# CLIO 2 RS

**Cancels and replaces Technical Note No. 4296A dated NOVEMBER 2002.**  
**Modifications:** changes to technical solution

## 10A ACCESSORIES BELT SLIPS OFF: ENGINE NOISE AND WARNING LIGHT COMES ON

X – Gap value at least **3 mm**

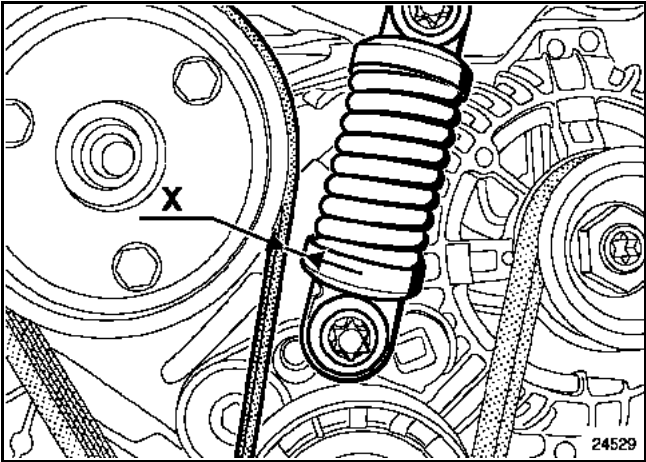
- Use a set of feeler gauges to measure gap (X) between the accessories belt and the adjustable tensioner body.

Gap (X) between the accessories belt and the adjustable tensioner body **MUST** be at least **3 mm**. If gap (X) is smaller than **3 mm**: fit a new accessories belt and check again.

- Replace:
  - the accessories belt,
  - the adjustable tensioner,
  - the air conditioning compressor mounting,
  - the air conditioning compressor,
  - the power assisted steering pump if the part number is different to **82 00 234 212**.
